**PLANNING CONSULTATION BY THE
LONDON BOROUGH OF TOWER HAMLETS**

**DEMOLITION OF THE EXISTING BUILDING AND REDEVELOPMENT OF THE
SITE TO PROVIDE COMMERCIAL SPACE (CLASS E) AND RESIDENTIAL
ACCOMMODATION (CLASS C3) WITH ASSOCIATED INFRASTRUCTURE AND
WORKS, INCLUDING RECONFIGURATION AND UPGRADES TO THE
ADJOINING PUBLIC GARDEN**

SITE AT NORTH EAST OF ATLANTIC COURT, JAMESTOWN WAY, LONDON

Proposed Elevations

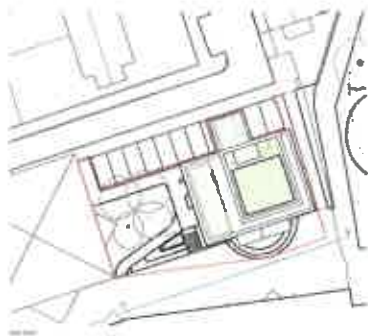
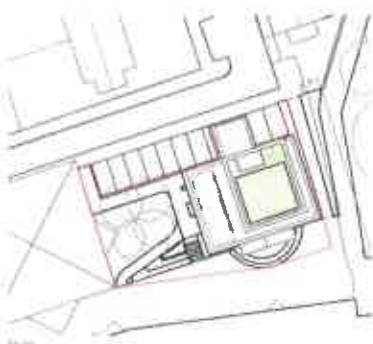
The proposed development will be considerably larger than the existing single storey Rotunda Building both in terms of its height and mass. It will also be taller than the other buildings within the Virginia Quay development which sit adjacent to the western boundary of EIDB. These buildings are at three storeys and their impact on the Basin is partially softened by vegetation within EIDB. The visual impact of the proposed development is difficult to assess however as it varies considerably depending on the viewpoint. In more distant views for example when viewed from the opposite, eastern side of the Basin (i.e. looking west) the new development is likely to be largely screened by the small but substantial area of woodland within the southwest corner of the Basin, although it is likely to be partially visible above the tree line. It also sits within a viewing context that includes a range of other buildings of varying heights ranging from five, eight and eleven storey apartment blocks. Behind or beyond this, there are much taller buildings and together the views are of a mix of construction styles, design and cladding materials.

- 23 From the southern part of the Basin and viewed when approaching the exit point in the south west corner, the proposed development will dominate and being slightly taller than the Atlantic Court block will consolidate the built, developed edge to the Park. For people entering the Park from the Thames Path, it will

also start to intrude on views of the wooded green edge to the Basin in the southeast corner. The developed form will be noted as stepping up towards the Park even if only by one storey. It will also appear as a noticeably taller structure in the views of visitors following the path inside and around the south western edge of the Basin where adjacent development sits at 3 storeys.

- 25 The recent amendment to the choice of materials and colour palette is noted and considered acceptable. Opting for a pale buff coloured palette will enable the proposed building to respond to and sit as part of the existing residential area. The positioning of balconies on the southern and front elevation is also preferred in order to minimise disturbance to wildlife and habitats within EIDB.

- 26 On balance the visual impact of the new development is likely to be most noticeable to visitors on the approach to the Regional Park from the south west and in views out to the west from within the southern part of the Basin. Ultimately the building steps up towards the Park and whilst only a marginal change in the context of the existing 5 storey and 3 storey buildings closest to the Park boundary this is usually a matter the Authority seeks to resist, requiring development to step down as it approaches the Park boundary. It would therefore be appropriate to request that the applicant considers amendments to the design to take account of the adjacent Park edge and entrance to EIDB and considers a form that reduces in height and achieves a more positive relationship with the Park.

- 33 These discussions would also open up the potential to discuss with the applicant and the Council an amended design for the apartment building that reduces its height taking account of its visual impact on the south western part of EIDB and the entrance point into the Regional Park.

Site at North East of Atlantic Court, Jamestown Way, London
 Illustrative Landscape Masterplan
 14th December 2023 Scale 1:100 @ A1
 BD 0318 SD 802 R04

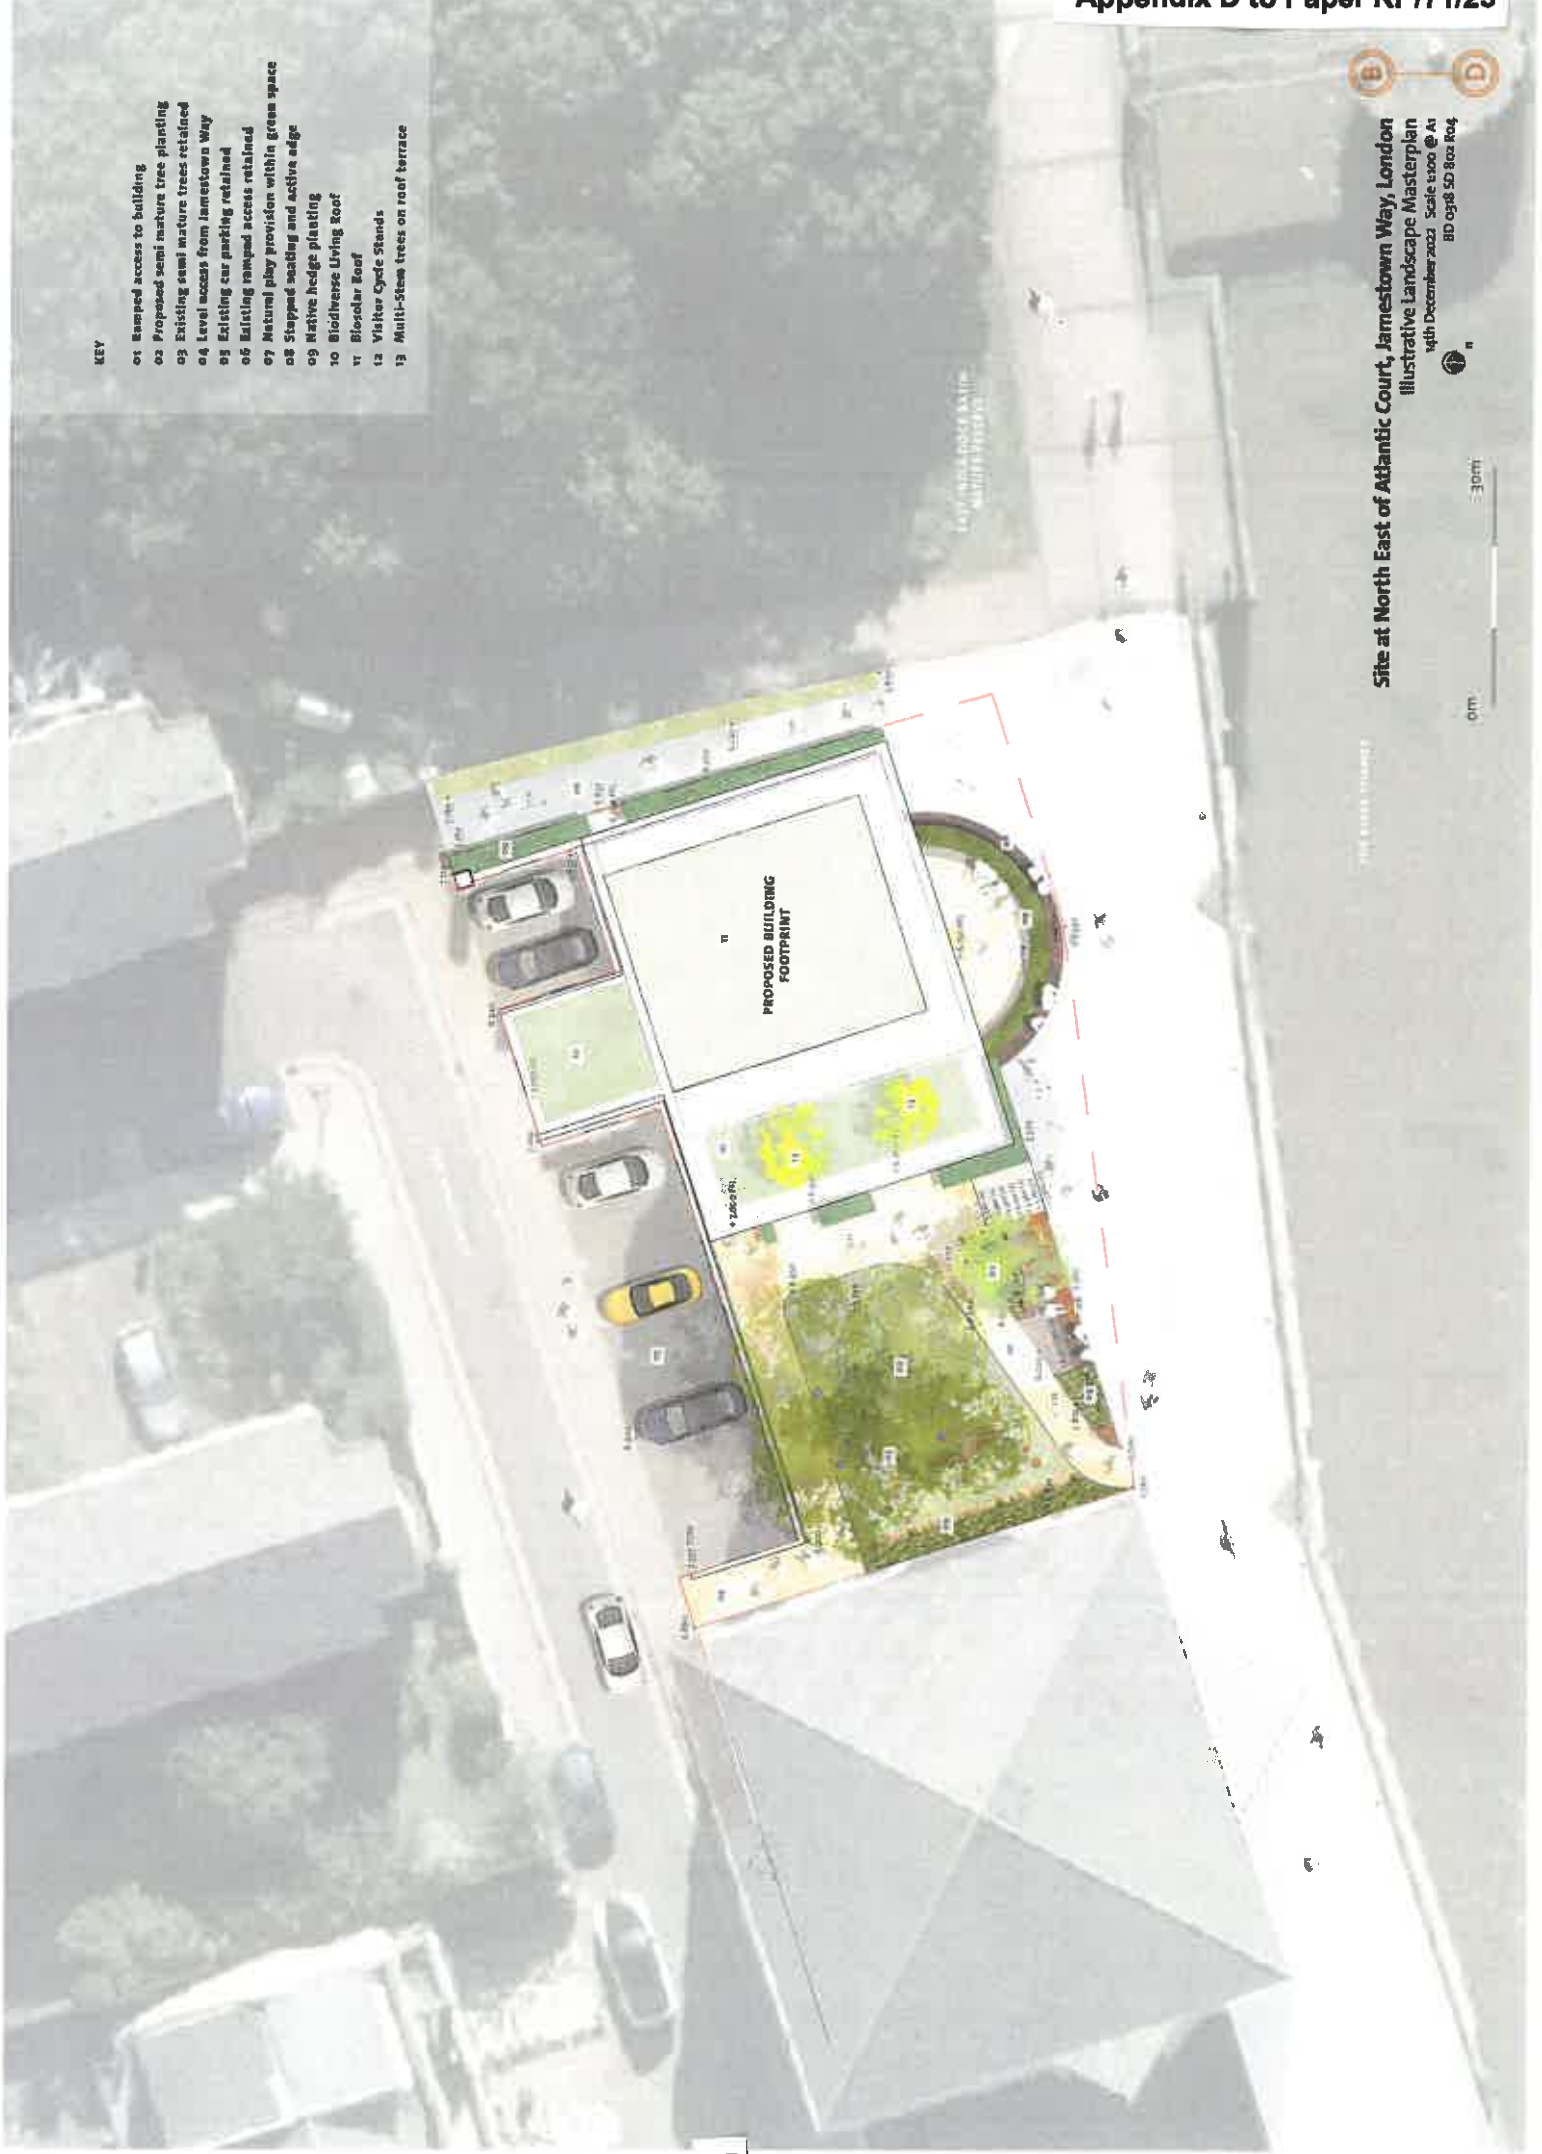
- 24 The applicant has highlighted the quality and accessibility of the reconfigured open space with the opening up of direct access from the River Thames path. This will indeed be an improvement and provide a welcome contrast to the areas of hard surfaced public space to the west alongside the riverside path. It will however be sandwiched between the Atlantic Court block and the proposed development and therefore largely hidden from EIDB and views out. It does not assist in reducing the impact of the building at the entrance point to EIDB in the south.

- 29 The reconfigured open space will deliver 87sqm of useable green space, a net uplift of 2sqm. The design of the open space is an improvement on the existing, with a much more inviting relationship with the riverside path and the incorporation of natural play space and more biodiverse landscaping. This will serve both residents and the general public. Whilst it is clear that some of the new residents will be using EIDB for informal recreational purposes the small scale (approx. 30 new residents) of the development is unlikely to substantially increase footfall within EIDB, given the existing residential context.
